Private Fuel Storage, L.L.C.

**SUBMITTAL OF COMMITMENT RESOLUTION INFORMATION
PRIVATE FUEL STORAGE FACILITY
DOCKET NO. 72-22 / TAC NO. L22462
PRIVATE FUEL STORAGE L.L.C.**

ENCLOSURE

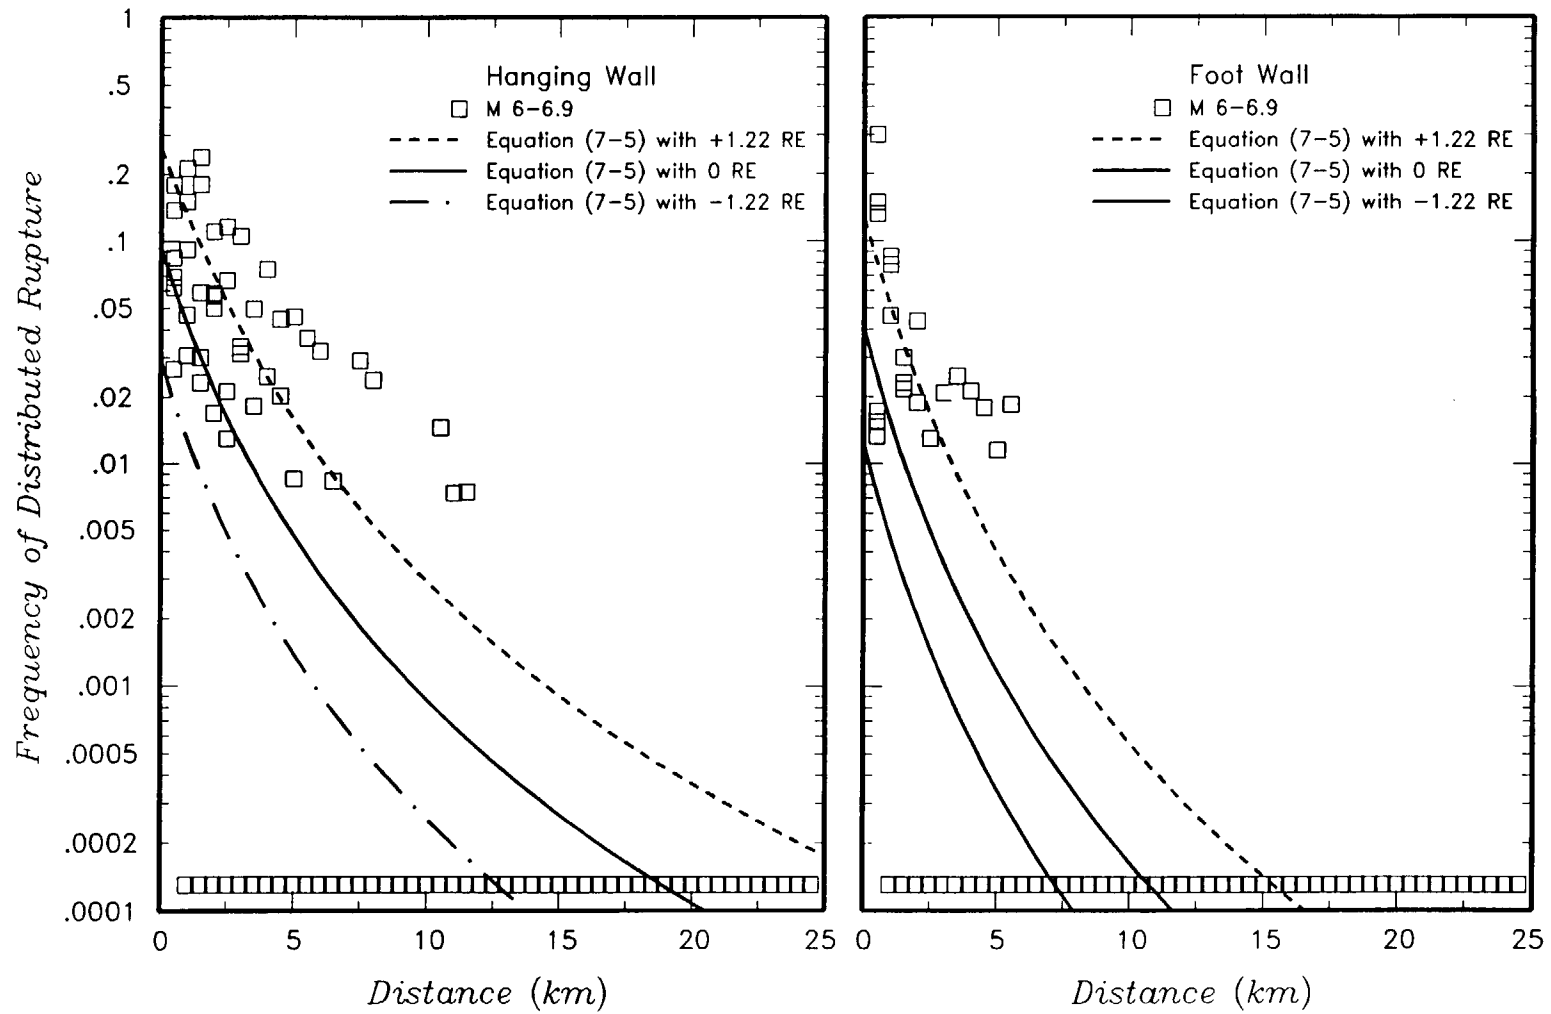
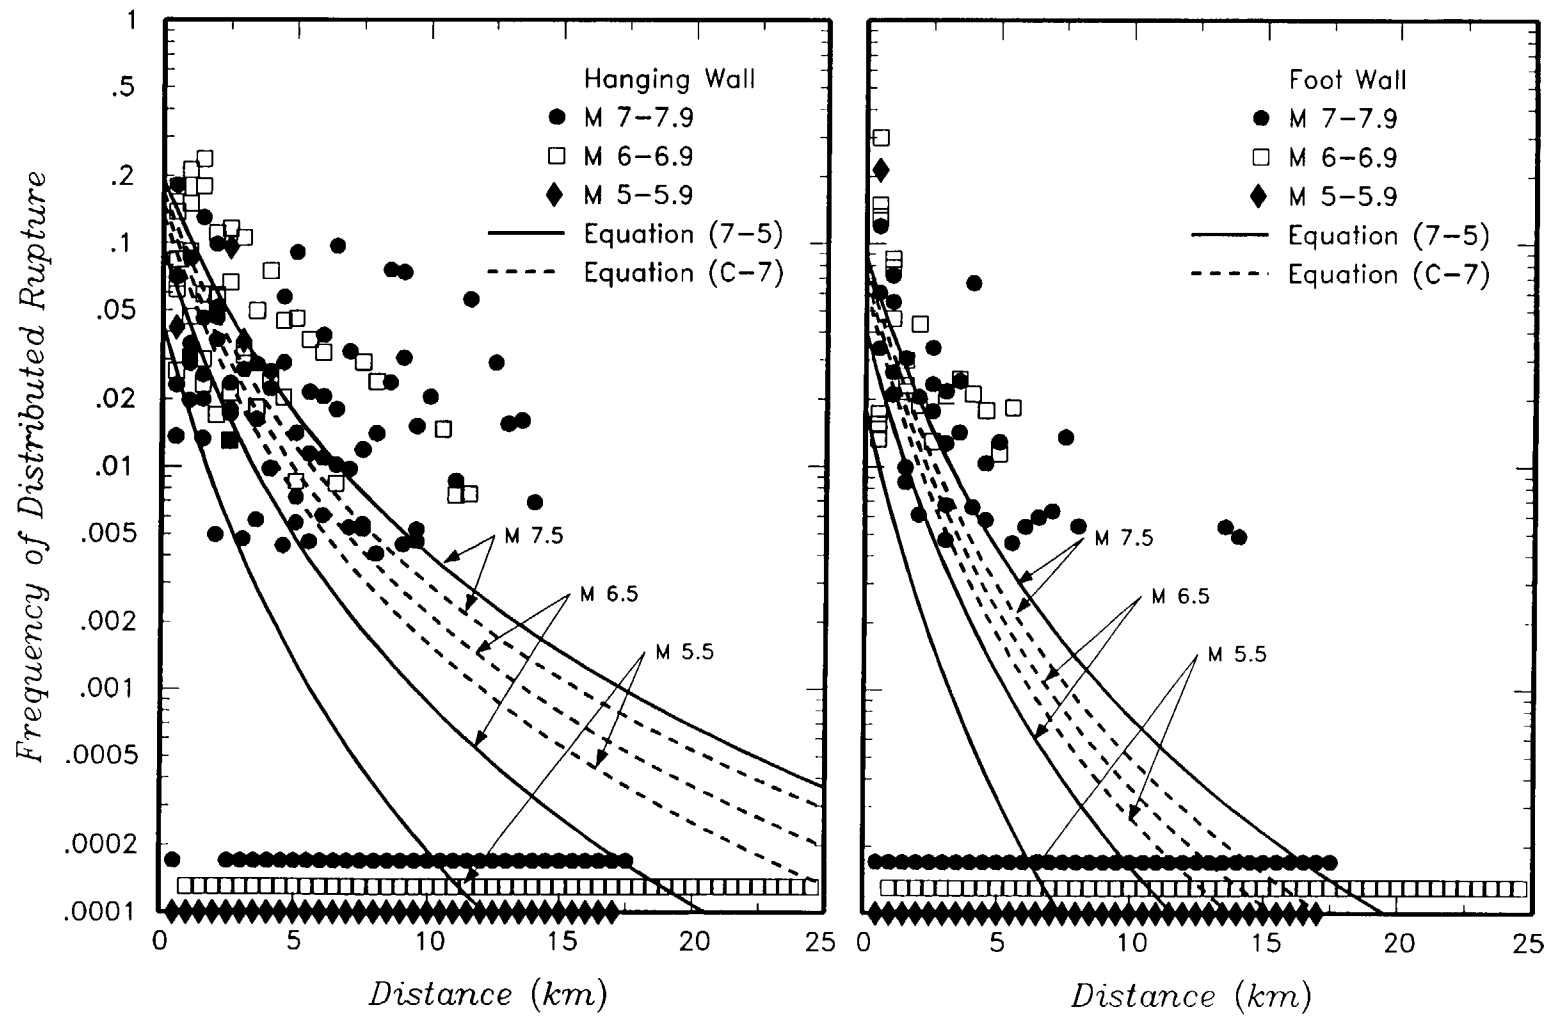
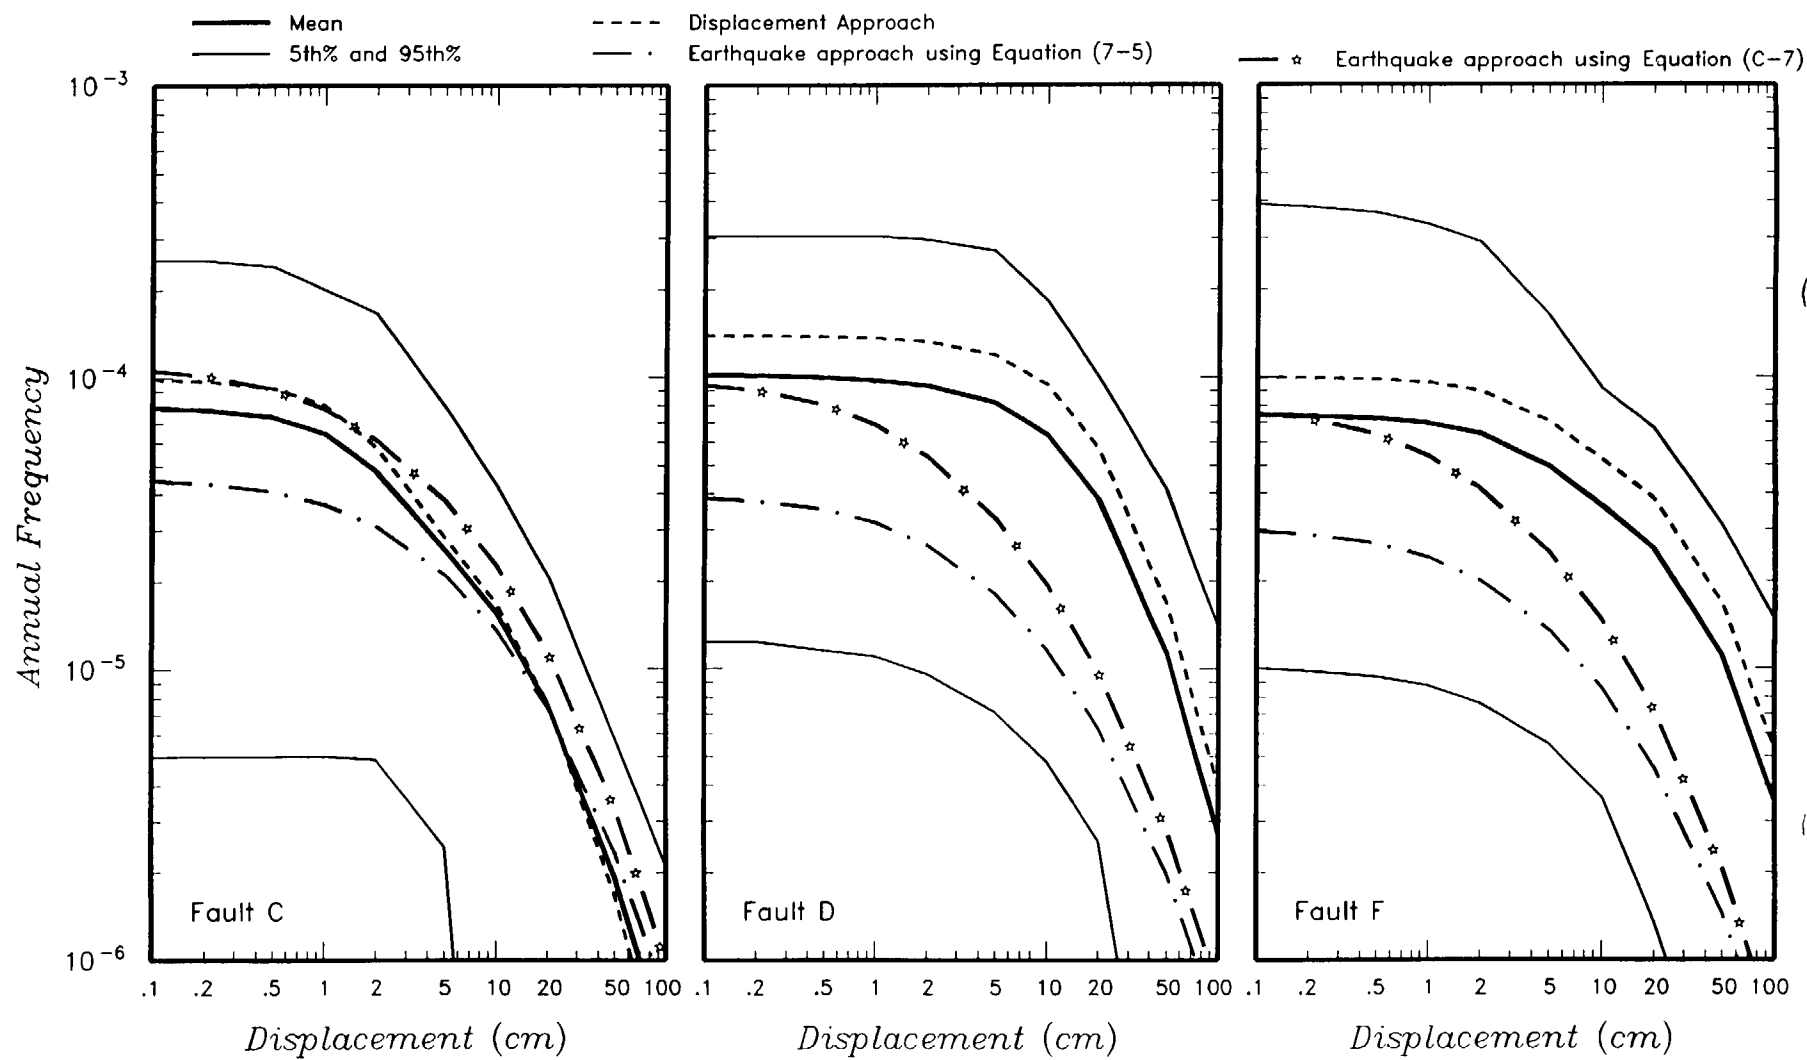
NRC Comment – Some of the equations provided by the Geomatrix report (Sections 6 and 7) in support of the response to RAI 2-5 are not clear with respect to some of the variables used. Also, equations used in conjunction with the Yucca Mountain studies are not clear as to their applicability to the PFSF site.

PFS Response – A clarification of the PSHA formulation is provided as Attachment 1.

in which h is 1.0 if the site lies in the hanging wall of the rupture and 0.0 if the site lies in the foot wall, and τ is a random variate with 0 mean and unit variance that accounts for variability from earthquake to earthquake. When Equation (7-5) is used to compute the probability of distributed slip, the mean value of $P_i(\text{Slip} | \text{Event on } j)$ is found by integrating over the random effect distribution. Figure C-1 shows the variation in the predicted probability of distributed rupture for a magnitude 6.5 earthquake as the random effect τ is varied from -1.22 to $+1.22$, corresponding to a ± 2 standard deviation range for a normal variate which encompasses 95% of the probability mass. Note that the curves shown on Figure C-1 represent a balance between the data with non zero densities of distributed faulting and the larger mass of data with observed zero density of distributed faulting show by the data points at the bottom of the plots.

Figure C-2 compares the predicted probabilities of distributed slip obtained using Equation (C-7) to those obtained using Equation (7-5) with the random effect set to zero. The values obtained using Equation (C-7) are much less sensitive to earthquake magnitude. Figure C-3 shows the effect on the computed displacement hazard of using Equation (C-7) instead of (7-5). At a displacement of 1 cm, there is about a factor of two increase in the frequency of exceedance. The difference between the two results decreases as the displacement level increases. The difference between the two results is primarily due to the lower rate of attenuation of the predicted probabilities of distributed slip from Equation (C-7), which results in a greater contribution from events at larger distances. Because of the attenuation in the amount of slip with distance, these events contribute more to the hazard for small displacements than large displacements. The resulting mean hazard curve using Equation (C-7) in the earthquake approach remains

near or below the hazard computed using the preferred displacement approach. Thus, the overall effect on the total hazard is small.
